collaborative solutions for flood control and habitat restoration

Re: Joint comments of Friends of the River, Sierra Club, and South Yuba River Citizens League on Oroville Facilities Relicensing, FERC Project 2100, draft EIR

In the Matter of)	October 17, 2005
)	
State of California)	
Department of Water Resources)	Project No. 2100-52
)	
For a New Major License)	
Oroville Division, State Water Facilities)	
“Oroville Facilities”)

**MOTION TO INTERVENE
OF
FRIENDS OF THE RIVER
SIERRA CLUB
SOUTH YUBA RIVER CITIZENS LEAGUE**

Figure 8. Lookdown View. Main spillway gate above (with spillway extending to the right downslope). Ungated spillway below without any downslope spillway. See spillway sections used in figures 6 & 7. ACE, 1970

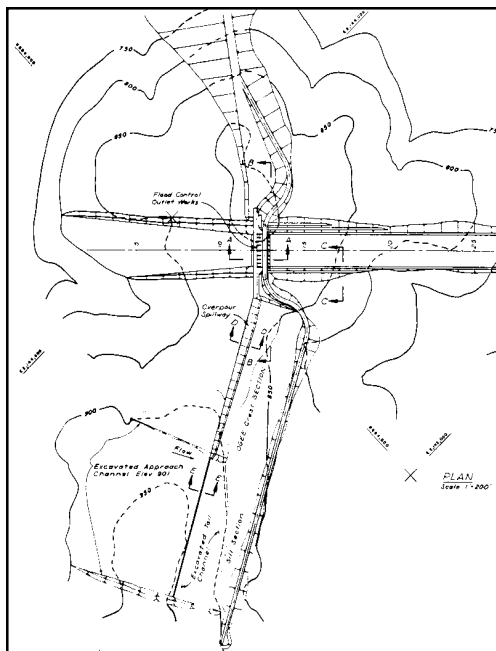
Obviously, a major issue in this relicensing is that the ungated spillway presently has the physical characteristics and consequences of use of an emergency spillway, but the required uses of an auxiliary spillway, imposing on the Commission the duty of requiring modification to the spillway.

One design approach to making the physical modifications necessary to achieve a larger flood pool at Oroville Dam is in violation of Federal law. If gates are installed on the ungated spillway, flood operations higher than 901 feet could be conducted using the main spillway. However, these gates would provide the physical facilities to impound Oroville Reservoir into the Bald Rock Canyon Wild River Zone of the Feather River wild and scenic river corridor.²⁸ The installation of such gates would require permission from the Federal Energy Regulatory
